AEOD/S97-01

OCONEE ELECTRICAL SYSTEM DESIGN AND OPERATION

SPECIAL STUDY

**Reactor Analysis Branch
Safety Programs Division
Office for Analysis and Evaluation
of Operational Data
U.S. Nuclear Regulatory Commission**

Figure 1 Oconee Emergency Electrical System

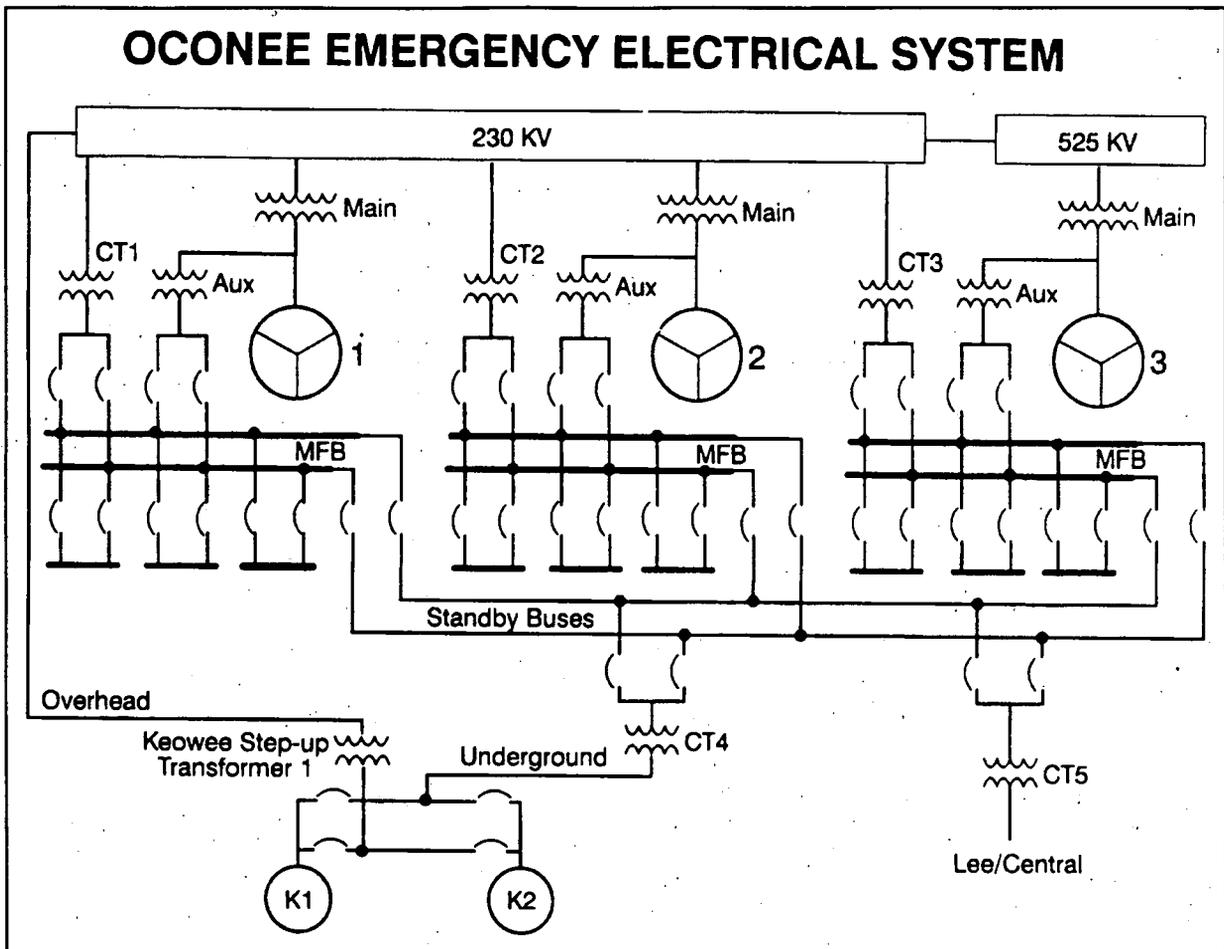
Since the overhead path for emergency power is through the switchyard, a LOOP event which originates in the switchyard can disable the overhead path as a source of emergency power. Operating experience at Oconee, as well as other U.S. nuclear plants, shows that this is the most likely LOOP scenario. Thus, the overhead path is more likely to be lost than the underground path.

In summary, the Oconee emergency power system design differs from other nuclear plants in the following major aspects: (1) power is supplied by hydroelectric units rather than diesels; (2) a failure in the overhead path through the switchyard can both cause a LOOP and disable one of the emergency power paths; (3) ac power to all emergency equipment for the three Oconee nuclear units may be supplied by a single Keowee hydroelectric generator unit; and (4) Keowee is used about six percent of the time to power the grid.

These aspects result in the following concerns relative to the normal configuration of diesels, respectively: (1) starting and load change dynamics of the large hydraulic turbine result in extended voltage and frequency transients compared to diesels, (2) the second power source path may be unavailable for a significant fraction of LOOP events (since most originate in the switchyard), (3) a failure of the Keowee governor or voltage regulator may affect all redundant safety equipment for a single-unit LOCA or LOCA/LOOP scenario and all connected equipment for a three-unit LOOP, and (4) a grid disturbance while both Keowee units are operating to the grid could both cause a LOOP and impact both Keowee units. The last two items could represent common-cause failure mechanisms.

Figure 2 Standby Shutdown Facility

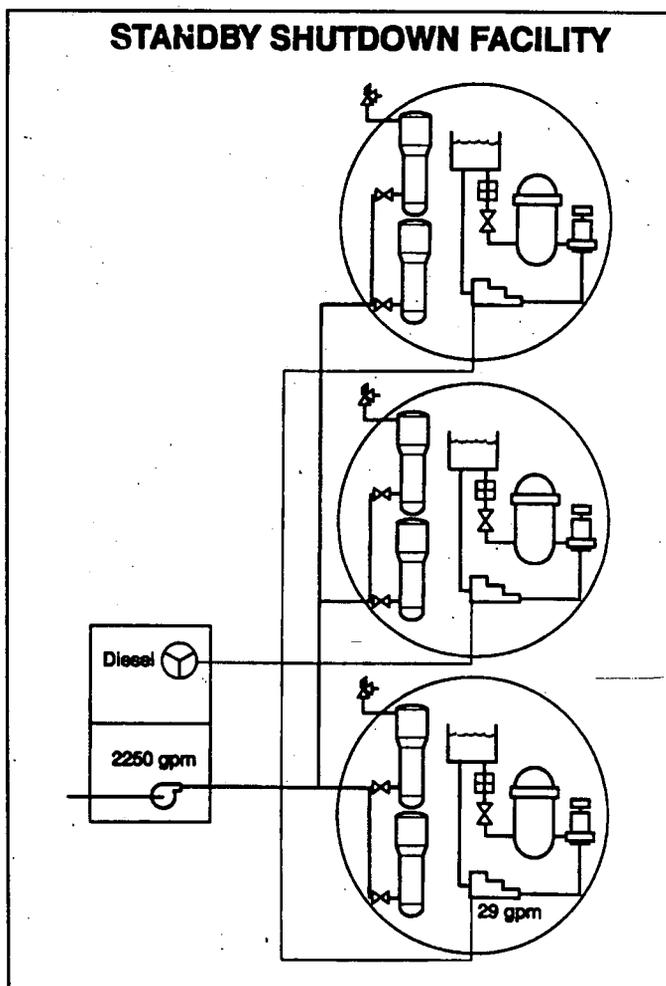
The Oconee individual plant examination (IPE) (Ref. 3) estimated that the SSF provides a risk reduction of approximately a factor of 6 for many core damage scenarios. Risk from LOCA scenarios are not affected by the SSF because its primary system makeup capacity is limited to 29 gpm.
